GUIDE

SIGNAL CORPS ENGINEERING LABORATORIES
FORT MONMOUTH NEW JERSEY

SM-C-178492

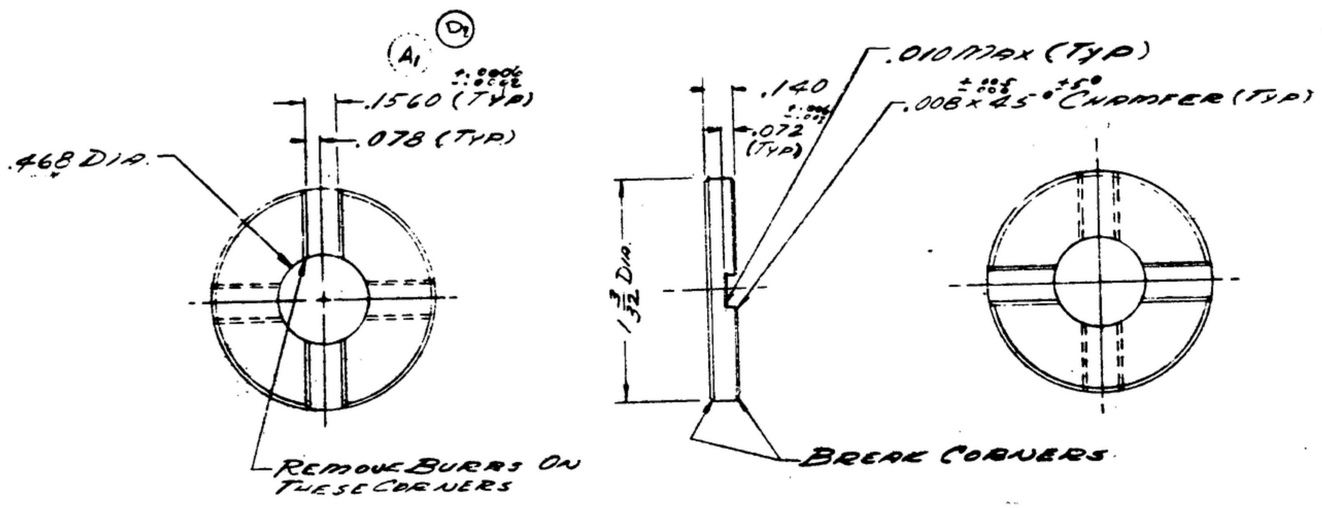
REVISIONS			
SYM	DESCRIPTION	DATE	APPROVAL
A_1	A_1 .1560 $^{+.0001}_{-.0002}$ DIMENSION WAS .1560 $^{+.0006}_{-.0002}$	6 DEC 61	3214-PP-59 REV'D PME
B	FINISH SPEC REVISED	[illegible]	[illegible] REV'D PME
C_1	(1) FINISH WAS COMP FM, COND B PER SPEC AN-S-771	23 MAR 1965	21582-R-61 REV'D PME
D_2	D_1 - REVISED NOTES, D_2 .1560 $^{+.0006}_{-.0002}$ WAS .1560 $^{+.0001}_{-.0002}$	26 MAY 66	6-00189 REV'D
